SUBJECT: ISSUANCE OF AMENDMENT NO. 25 TO AMENDED FACILITY OPERATING  
LICENSE NO. R-66 - UNIVERSITY OF VIRGINIA (TAC NO. MA3737)

UNIVERSITY OF VIRGINIA

AMENDMENT TO AMENDED FACILITY OPERATING LICENSE

Amendment No. 25  
License No. R-66

FIGURE 6.1 "A"  
 ORGANIZATIONAL CHART  
 UNIV. OF VIRGINIA NUCLEAR REACTOR FACILITY  
 (PRIOR TO SHIPMENT OF ALL FUEL ELEMENTS OFF-SITE)

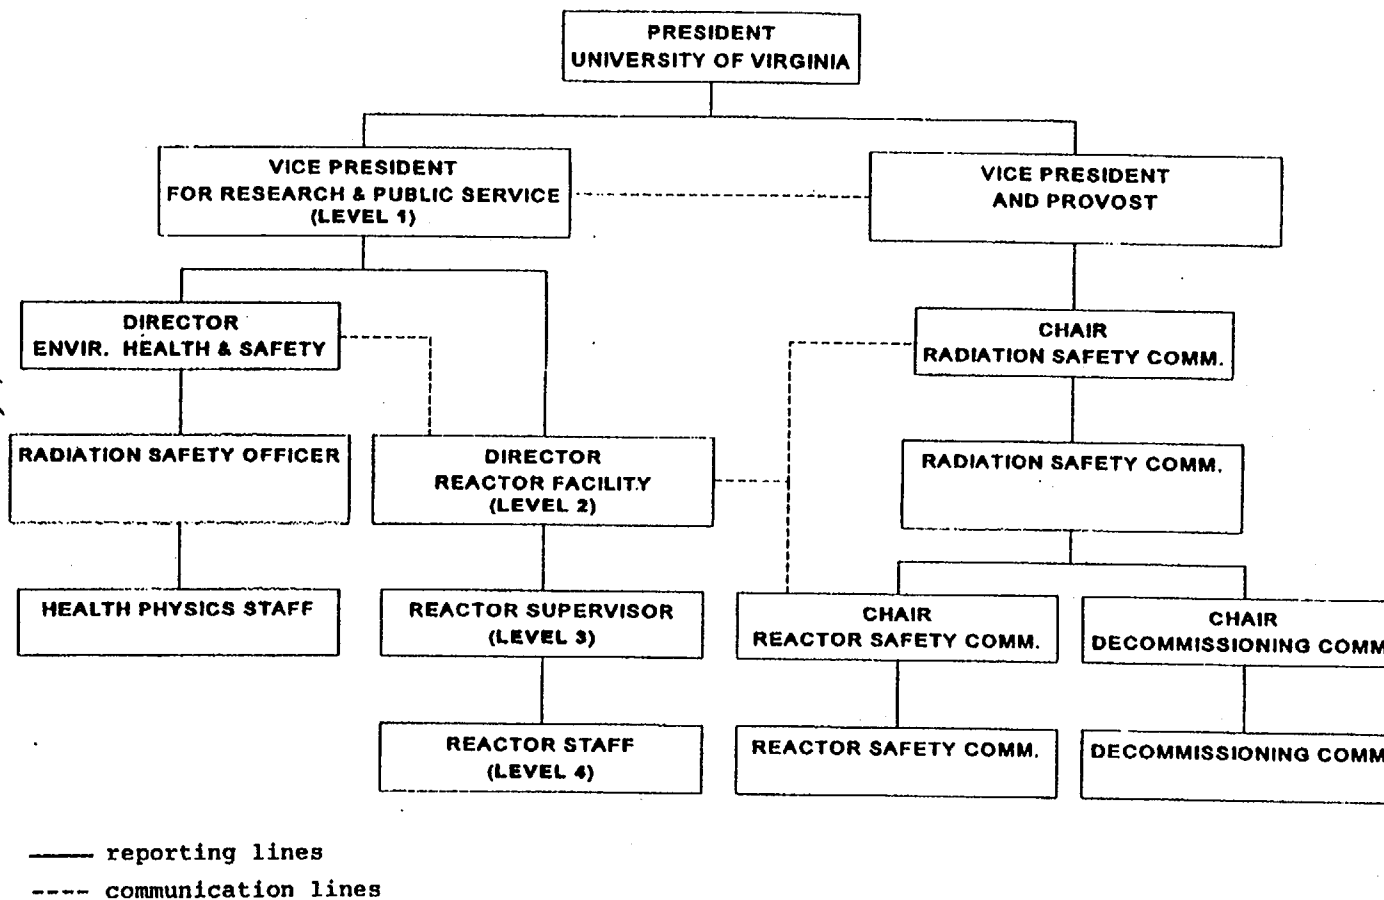
The licensee has proposed changes to the current organizational chart that is applicable prior to the shipment of fuel. A change is proposed to the level one management position to which the Reactor Director and Director, Office of Environmental Health and Safety report. The management position is changed from the Vice Provost for Research to the Vice President for Research and Public Service. This is a change in title only, and the level of upper management oversight remains unchanged. Because this is a change in title only and upper-level management oversight of the reactor facility is unchanged, this change is acceptable to the staff.

**FIGURE 6.1 "B"**  
**ORGANIZATIONAL CHART**  
**UNIV. OF VIRGINIA NUCLEAR REACTOR FACILITY**  
**(AFTER SHIPMENT OF ALL FUEL ELEMENTS OFF-SITE)**

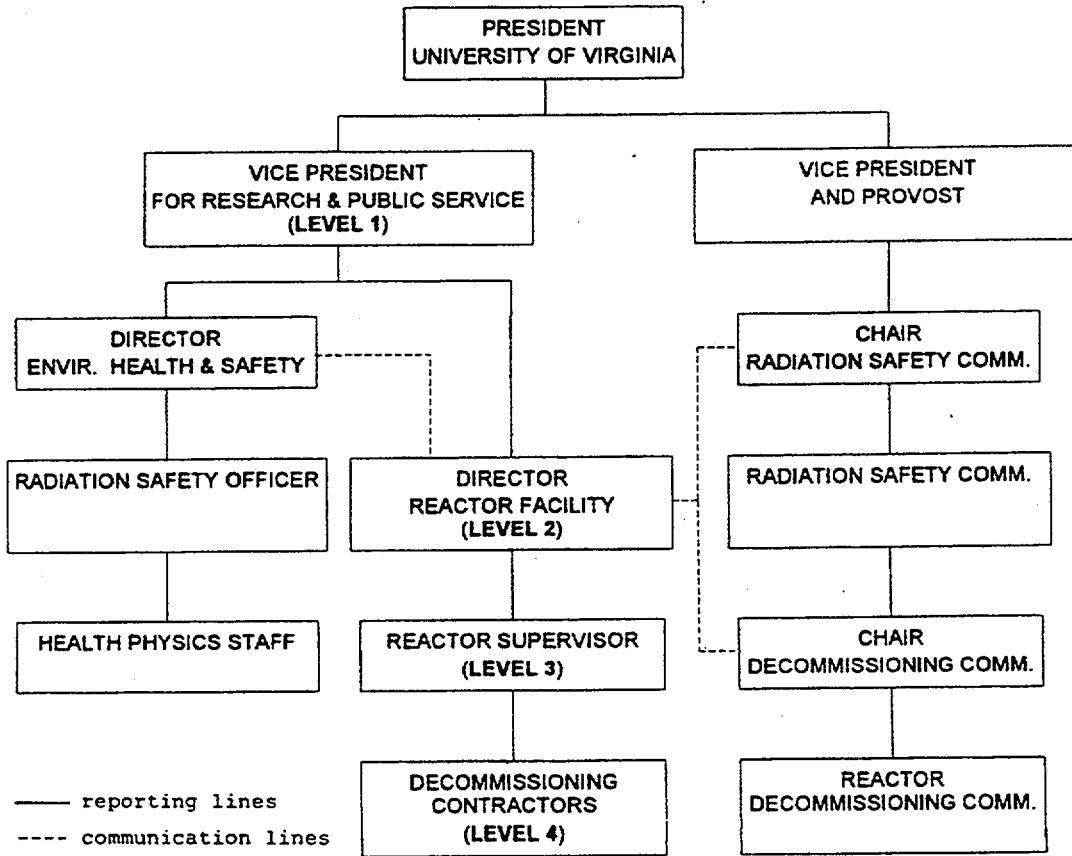
The licensee has proposed a second organizational chart which shows the facility organization after shipment of fuel offsite and the elimination of the Reactor Safety Committee. These changes are acceptable to the staff because the reactor will be permanently shut down, all fuel will be removed from the site and the Radiation Safety Committee and RDC will provide oversight of radiation protection and decommissioning issues.
